Access Compliance Report Public Rights-of-Way (Curb Ramps)

Main Street: CORPORATE_DR		Cross Street: CORPORATE_DR		Location:	NW
ADA ID: RPRK211116122612	Ramp Type: Type 4 - Parallel	Initial Pass/Fail: Pass	Overall Compliance: No	Severity Score:	25
Codes/Mitigation Info/Possible Solution			Field Measurements/Component Compliance

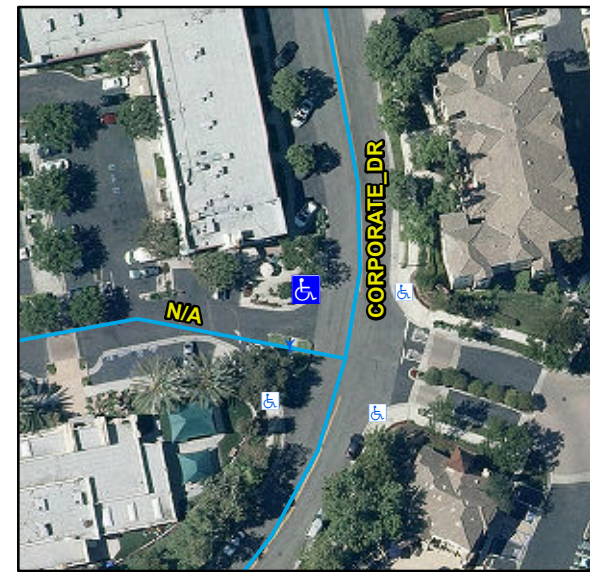
R304.2.1, R304.2.2-Perp, R304.3.2-Para, R304.5.3, R305, R304.5.4, STD 1115

Remove & Replace Curb Ramp With Two New Directional Ramps or Equivalent. Remove & Replace Gutter.
